PROJECT: Westcliff Pines 2 - Update #1

CITY OF LAS VEGAS INTER-OFFICE MEMORANDUM

Westcliff Pines 2 – Update #1

**UPDATE #1
TECHNICAL DRAINAGE
STUDY FOR
WESTCLIFF PINES 2**

FIGURE 11
REVISED

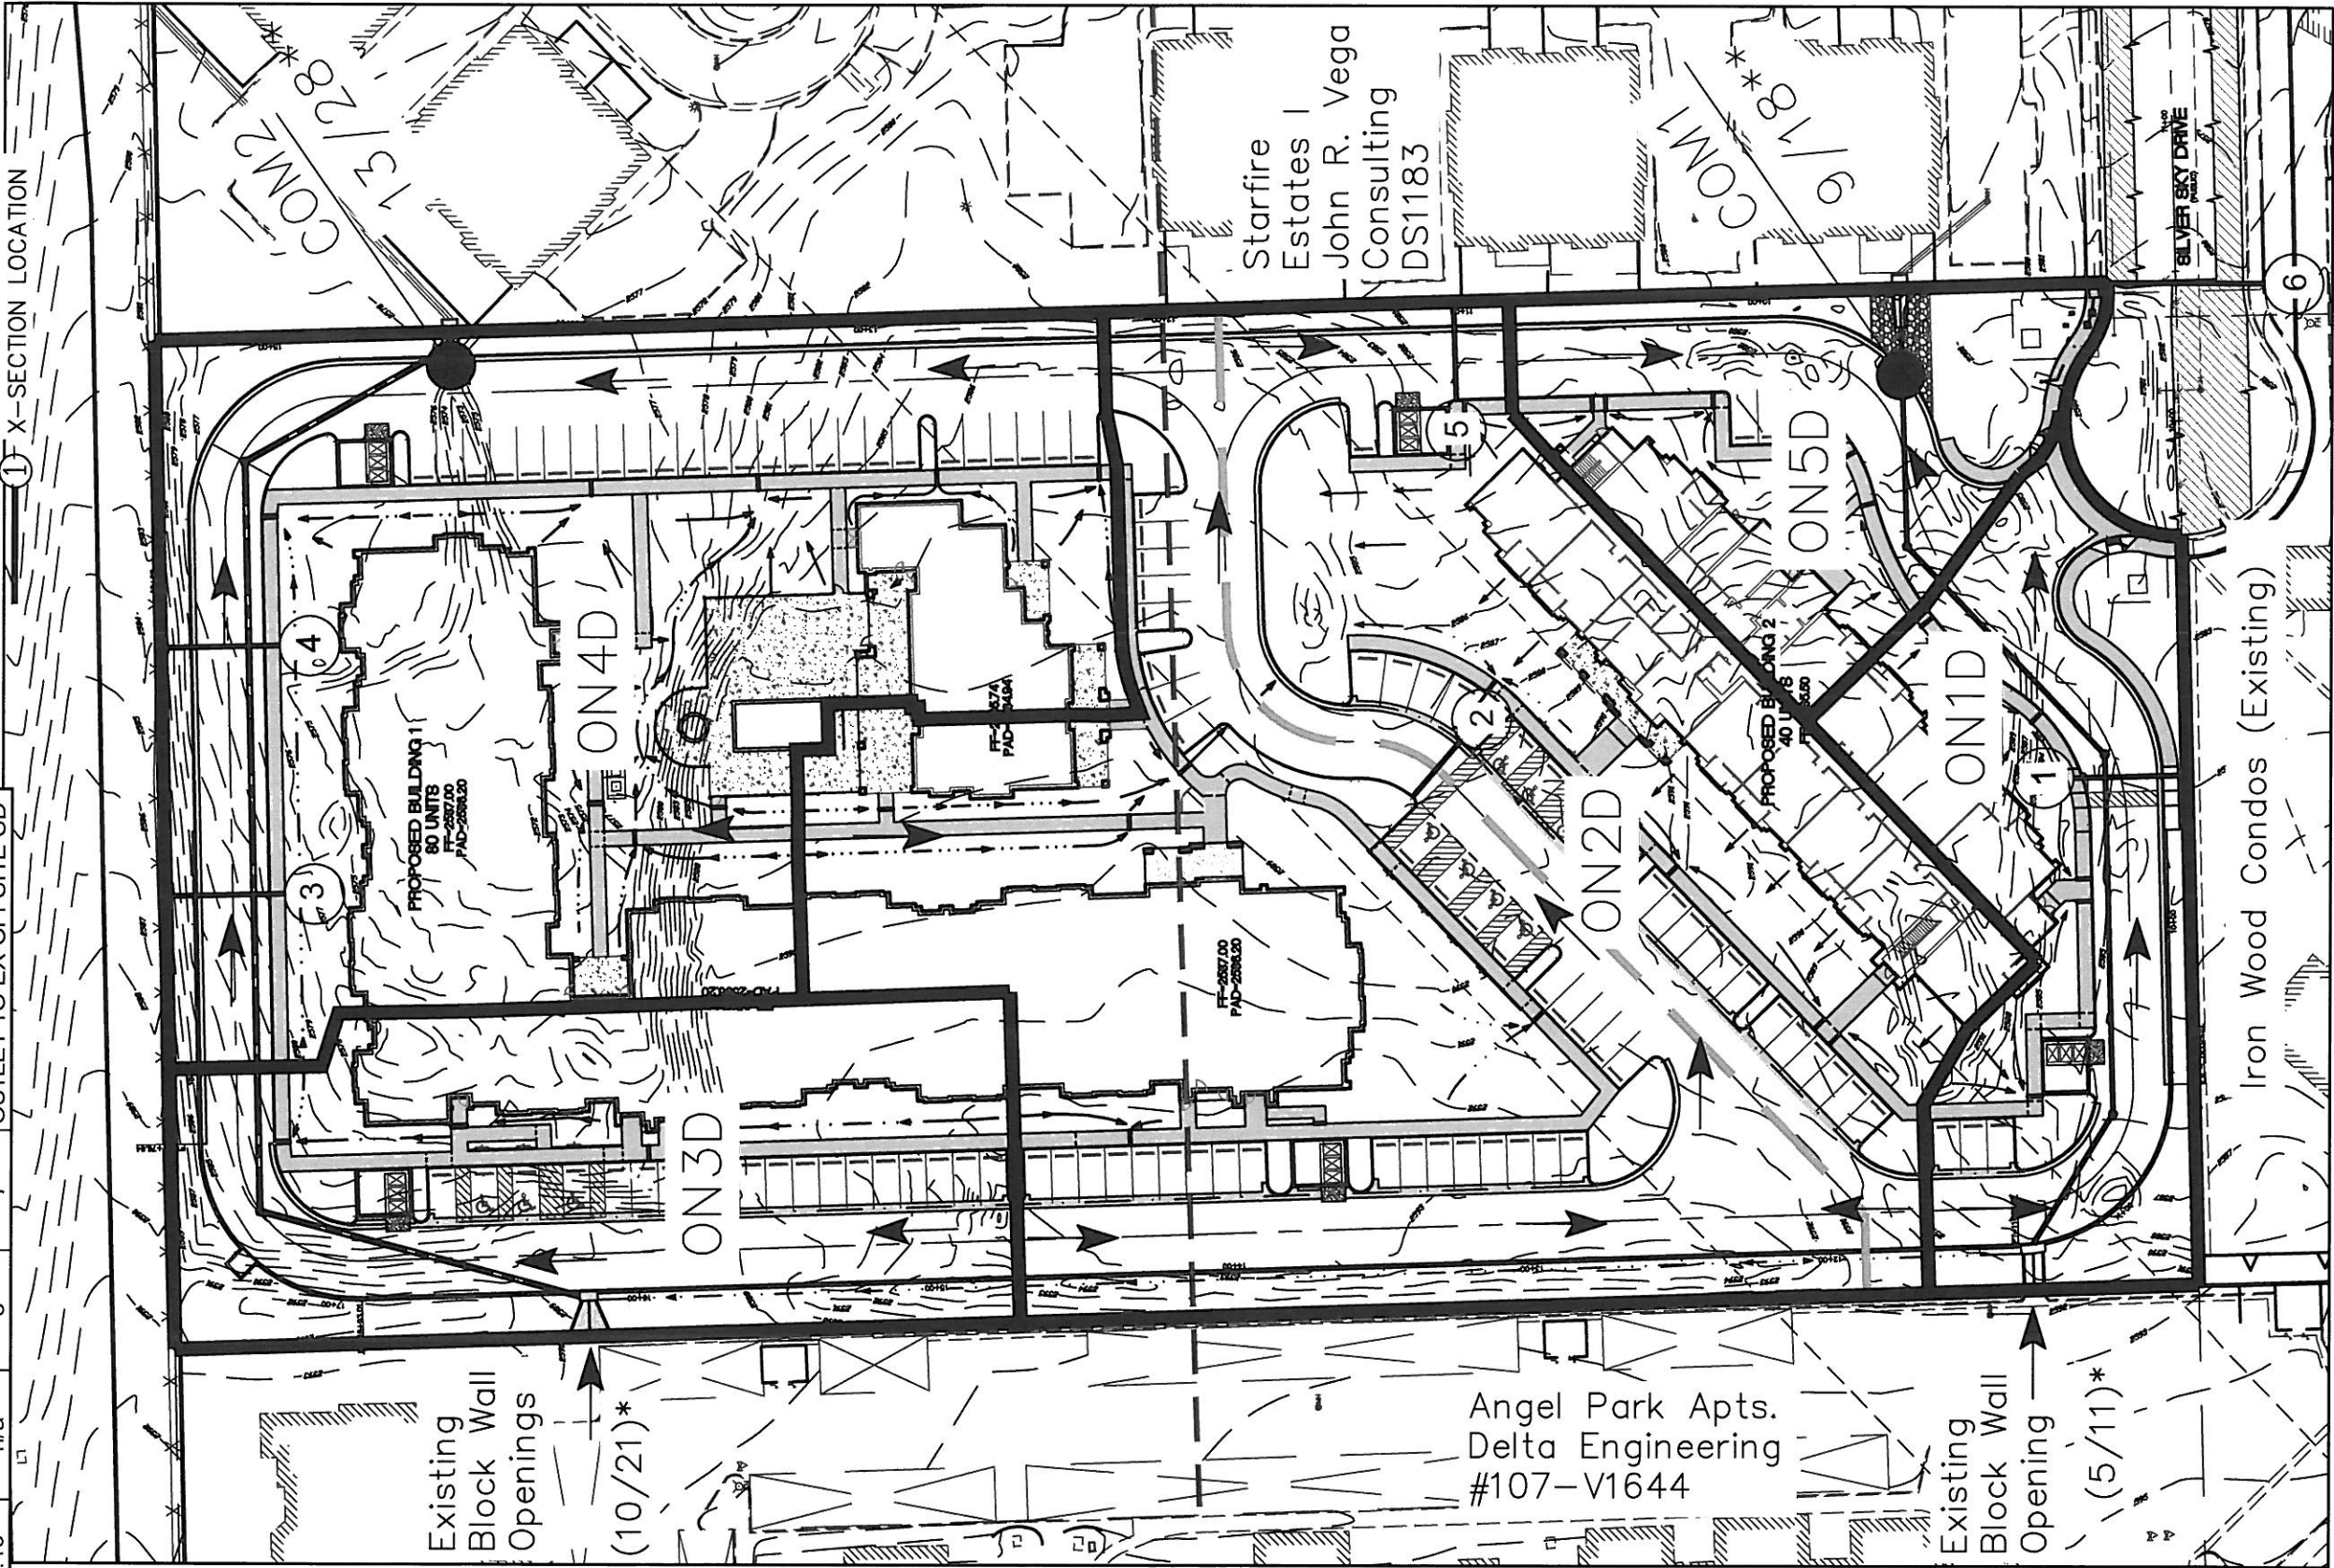
Revisions to the onsite drainage basins are shown on Revised Figure 11 in Appendix A. Basins ON2D, ON3D and ON4D configurations changed the storm runoff calculations were revised and results from the updated HEC-1 (Appendix B) indicate the 100-Year design storm flow rate remains unchanged. The 10-Year design storm flow rate is reduced by 1 cfs. Since the courtyard area storm drain system has been eliminated and the 1 cfs originally capture will now surface flow into the parking area and drive aisle along the northeast side of property. The 100-Year flow captured in the 10-ft Type 'A' drop inlet has increased from 6 cfs to 7 cfs.

GRADING PLAN 1

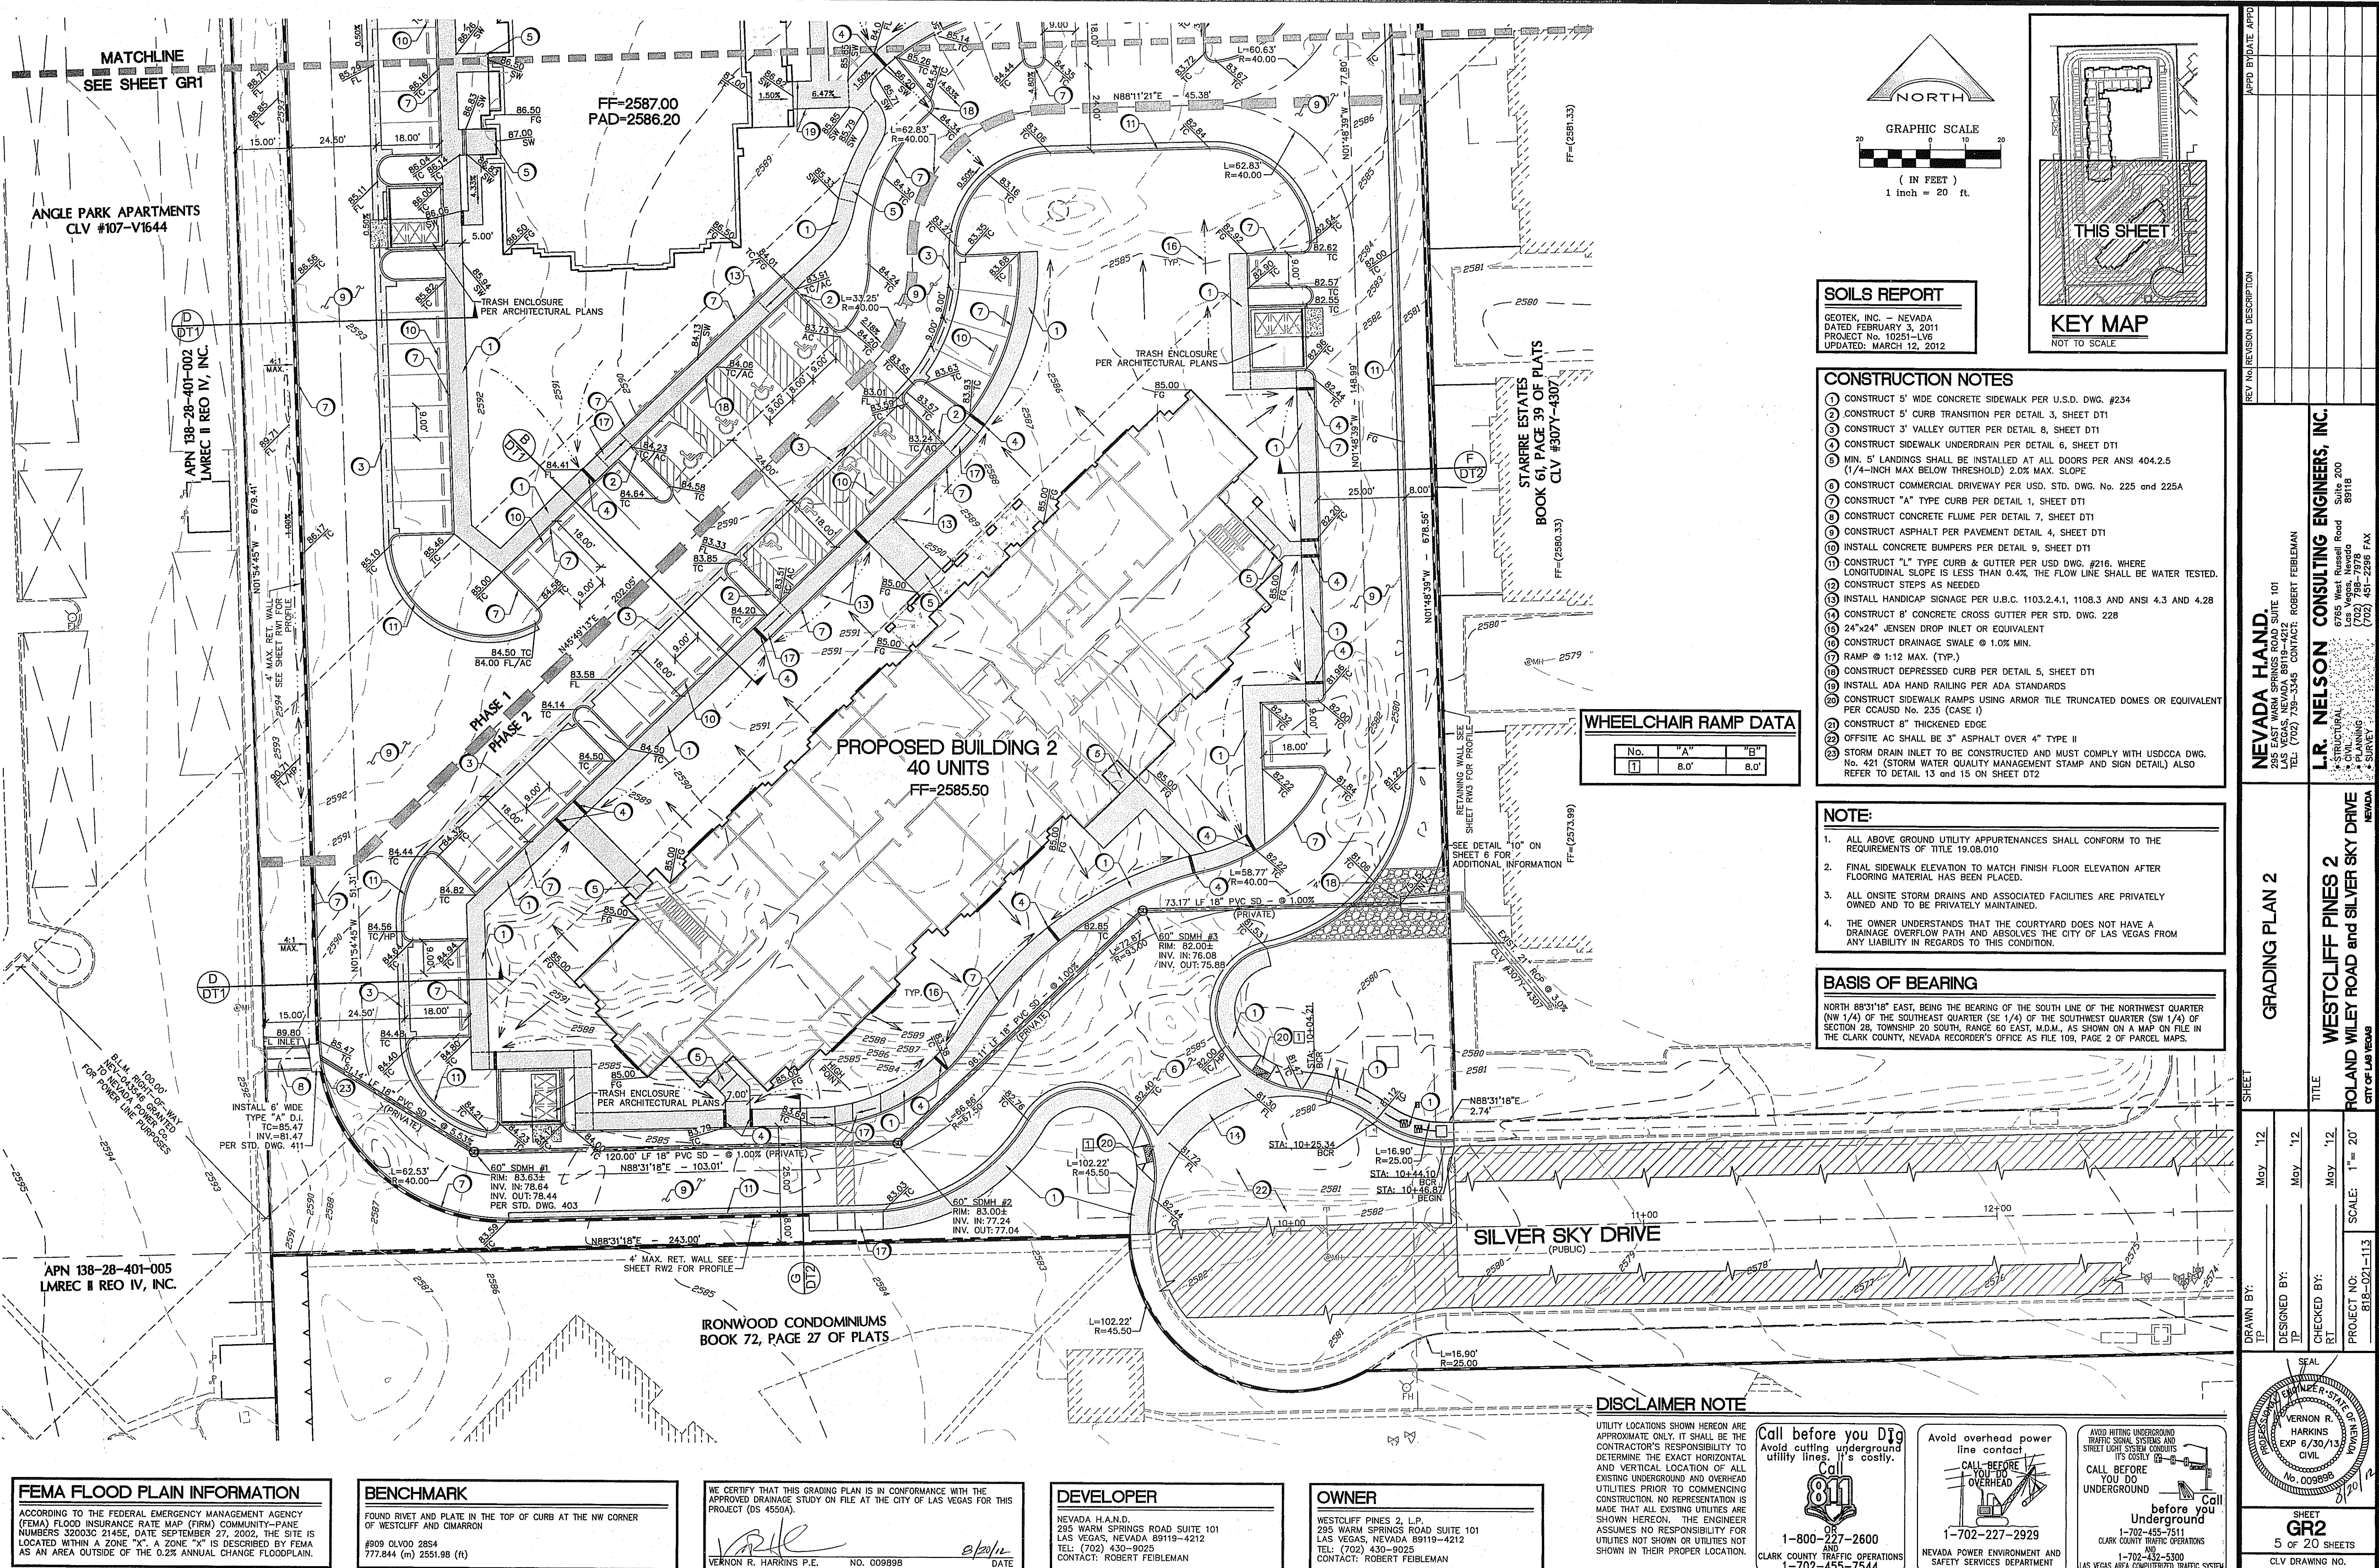
The original configuration for Building No. 1 was in the shape of "U" where the proposed footprint was shown in a North-South direction for the West and East portion connected by East-West section adjoining the two halves in one continuous structure. The proposed revision will eliminate the North-South building portion on the East half as shown on Sheet GR1 and will be replaced with a Community Recreation building along with a pool area. Proposed revisions are enclosed with a red bubble.

The area drains and connecting storm drain system within the original courtyard area have been eliminated within the Northern building. With addition of the Community Recreation building and pool area, the drainage patterns have been revised slightly to surface flow in the adjacent parking areas and drive aisle. The proposed site revisions for Westcliff Pines 2 are outlined within the red bubbled area shown on Sheets GR1, GR2, SD1 and DT1 with this submittal. With these changes, the drainage basins have been revised accordingly along with the northern onsite storm drain conveyance flow rate.

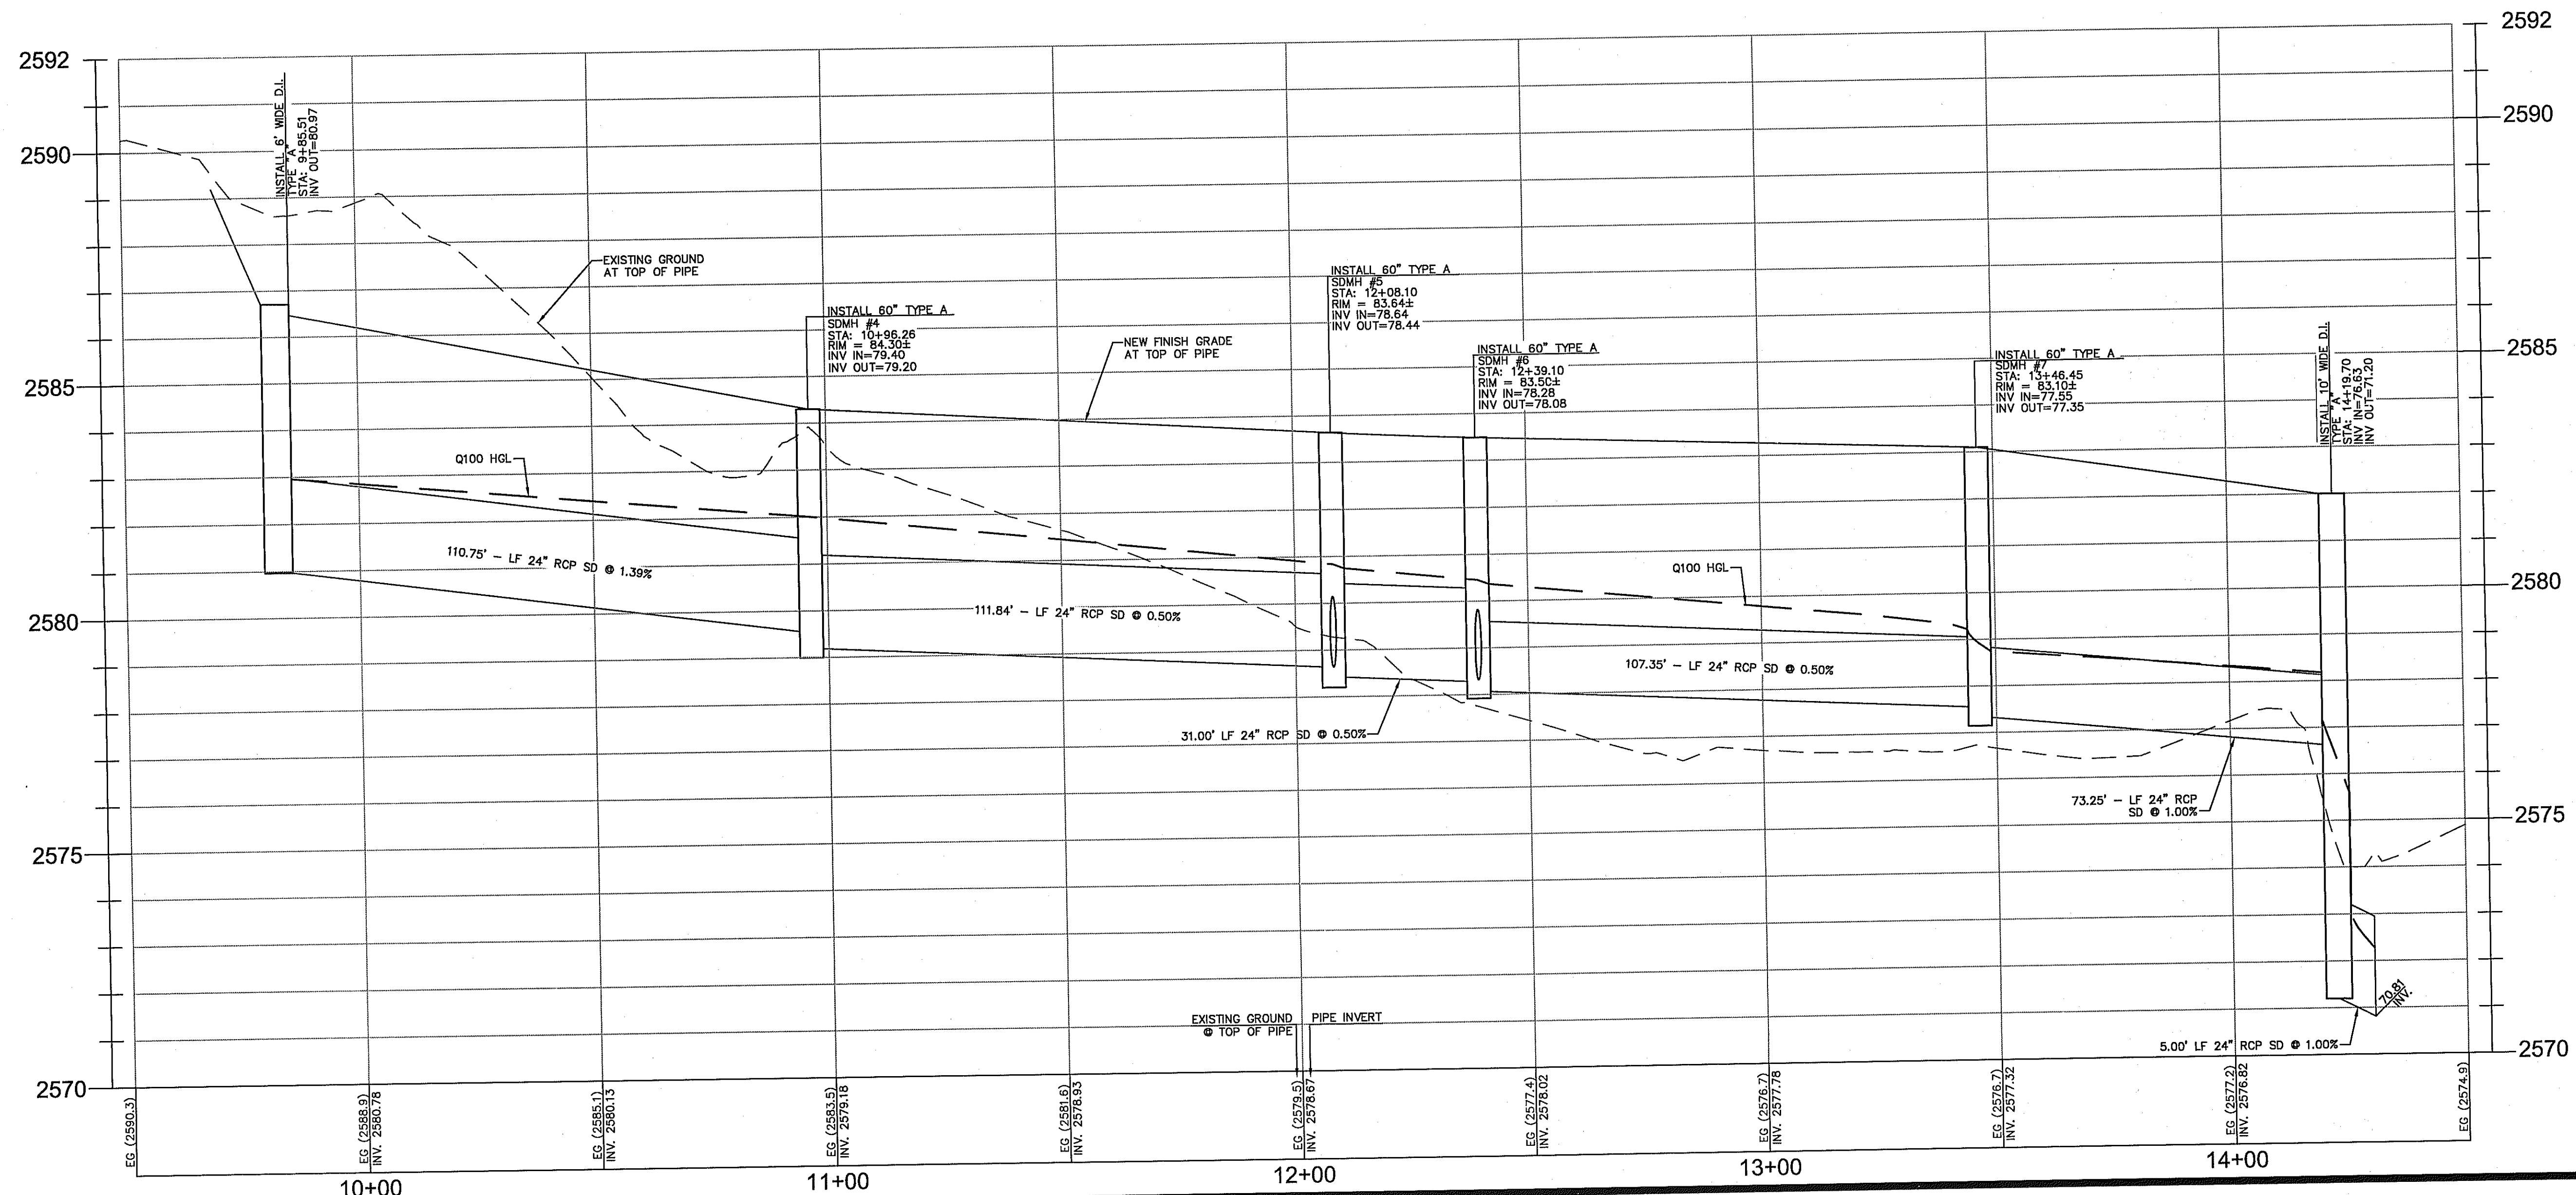
The minor changes to the drainage basins and updated hydrologic analysis indicate the previously design storm drain system will accommodate the revisions. Depth of flow calculations (Appendix C) are provided for cross-section 3 and 4 along the northern drive aisle for the 100-Year design storm flow rate. A revised capture depth at the entrance to the 10-ft Type 'A' drop inlet for the 7 cfs is included in Appendix C. An updated WSPG analysis (Appendix C) for the northern storm drain system has been provided for the 1 cfs removed from the courtyard area drain/storm drain system and added to the 10-ft Type 'A' drop inlet at COM2 node shown on the revised drainage basin map shown in Appendix A. Sheet SD1 profiles the revised storm drain system and updated 100-Year HGL.
